World Forum for Harmonization of Vehicle Regulations (WP.29)

PROPOSAL FOR DRAFT AMENDMENTS TO REGULATION No. 11

(Door latches and door retention components)

Corrigendum to document TRANS/WP.29GRSP/2005/9

Figure 3-4: Door Static Load Test Directions."

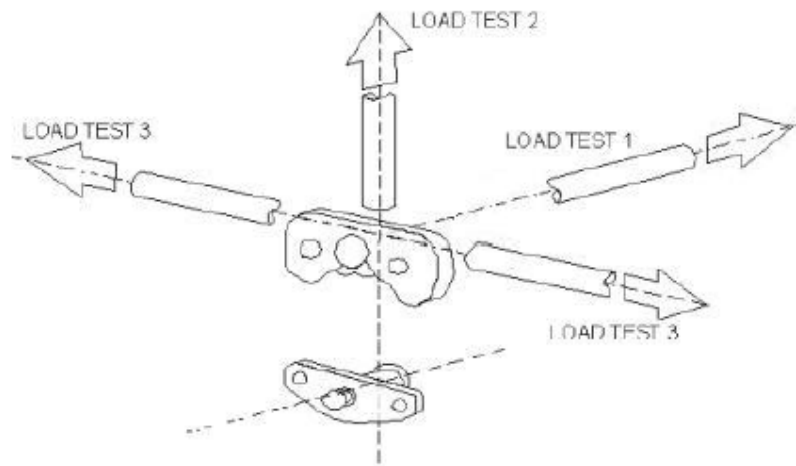
Replace Annex 3, Figure 3-4 with the following figure:
